Project No. 1744-22

October 31, 2024

ADDENDUM No. 3
to the
DRAWINGS AND PROJECT MANUAL
for
TARWATER VETERINARY CLINIC
802 E. CRINER ST.
GRANDVIEW, TEXAS

SHEET NUMBER
SA05
A002

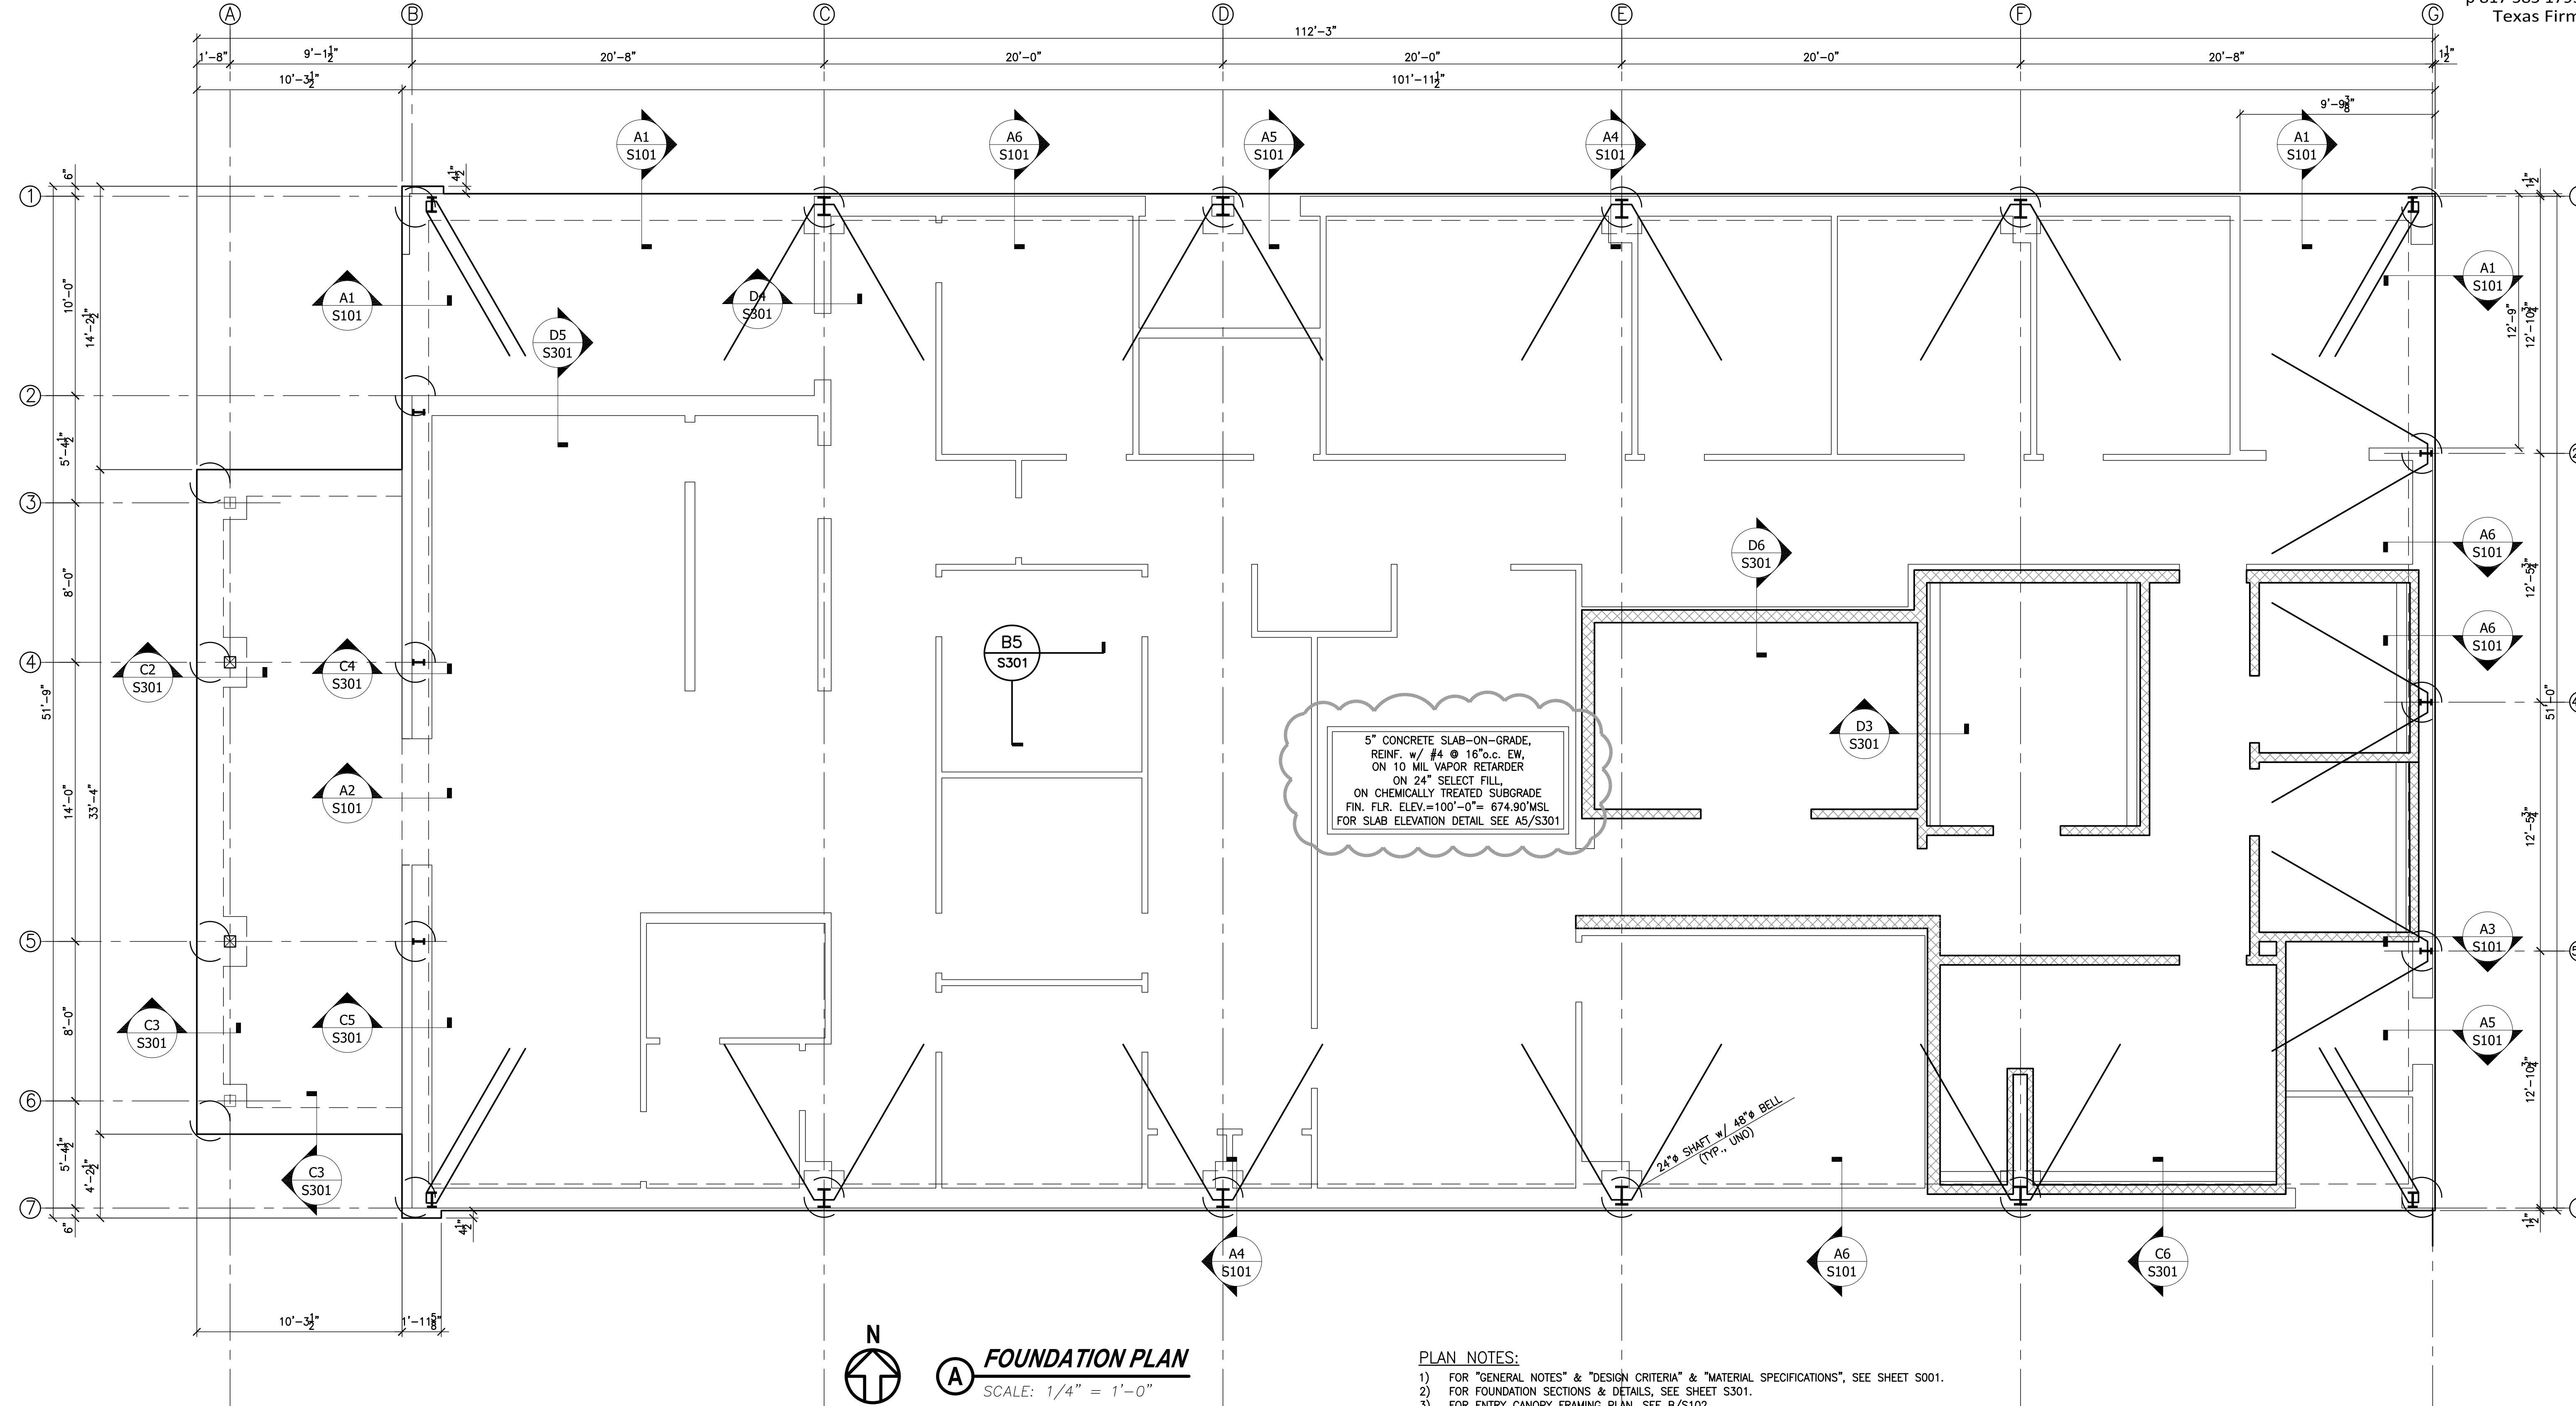
ADD this Section in its entirety as Resinous Epoxy Flooring to be Added to the Project Scope. Location & Application is indicated on Revised Sheet SA03-A002, as attached & included as part of this Addendum.
